City of Portland, Oregon
Bureau of Development Services
Land Use Services
FROM CONCEPT TO CONSTRUCTION

STAFF REPORT AND RECOMMENDATION TO THE DESIGN COMMISSION

CASE FILE: LU 16-174250 DZM AD
PC # 15-225430
NW 14th & Glisan
REVIEW BY: Design Commission
WHEN: August 25, 2016 @ 1:30pm
WHERE: 1900 SW Fourth Ave., Room 2500A
Portland, OR 97201

FLOOR PLAN - GROUND LEVEL

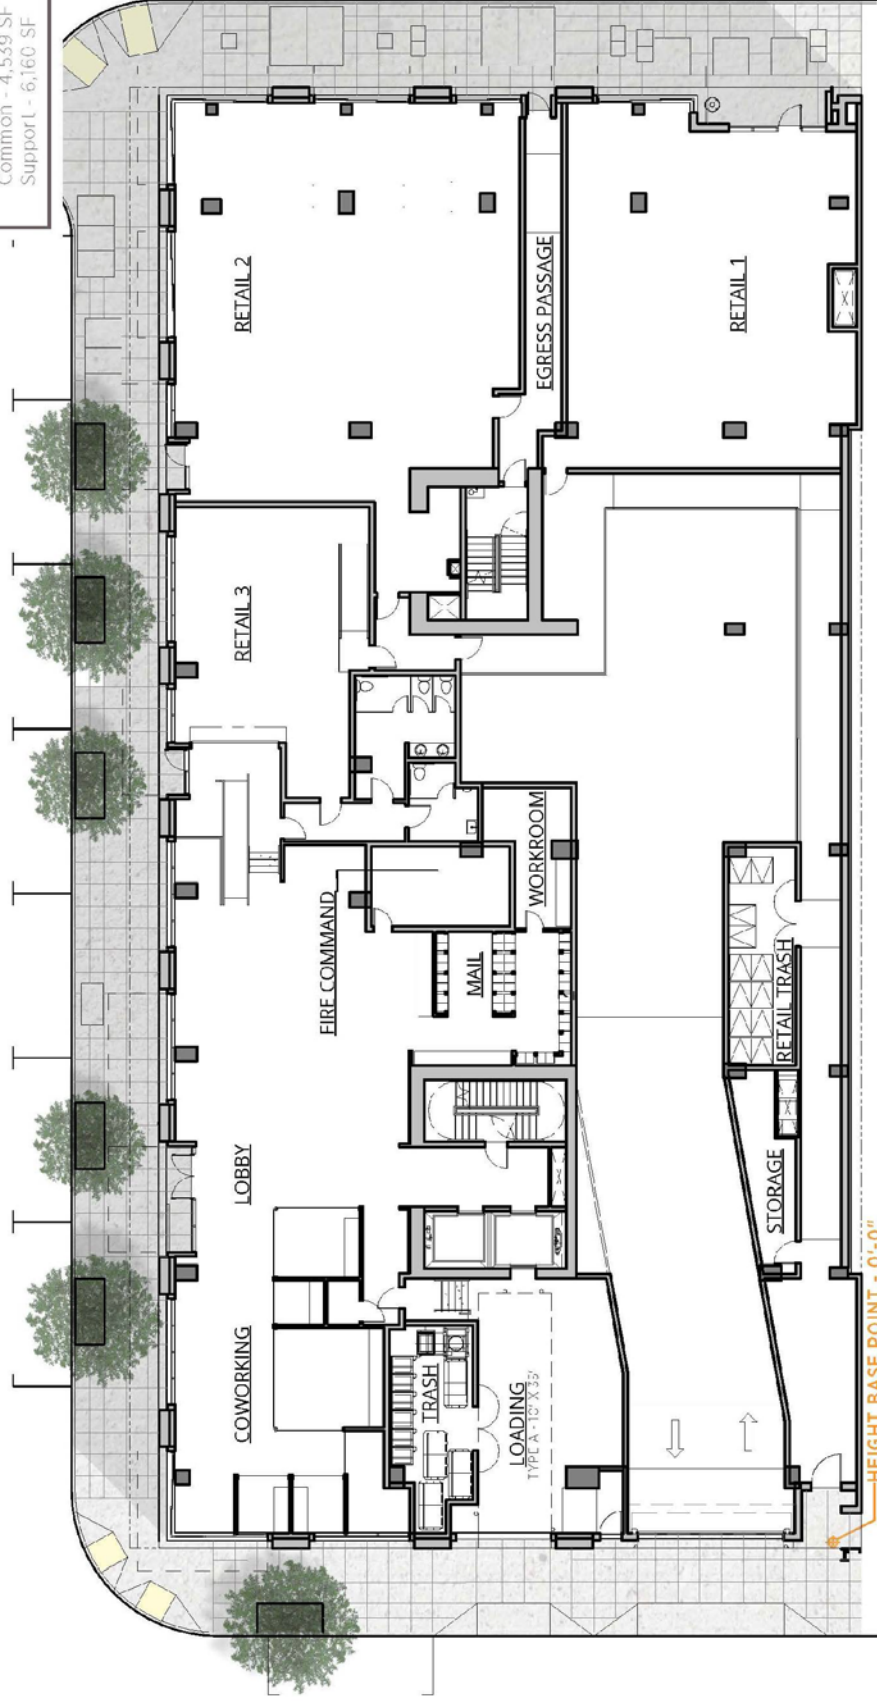
Findings: All entrances are designed to be barrier-free, thereby providing access to all. Staff notes, however, that the entrance to Retail 3 from the adjacent sidewalk appears to be somewhat convoluted and indirect, and may be a drawing error.

With resolution of the entrance to Retail 3 with direct access from the sidewalk, this guideline is met.
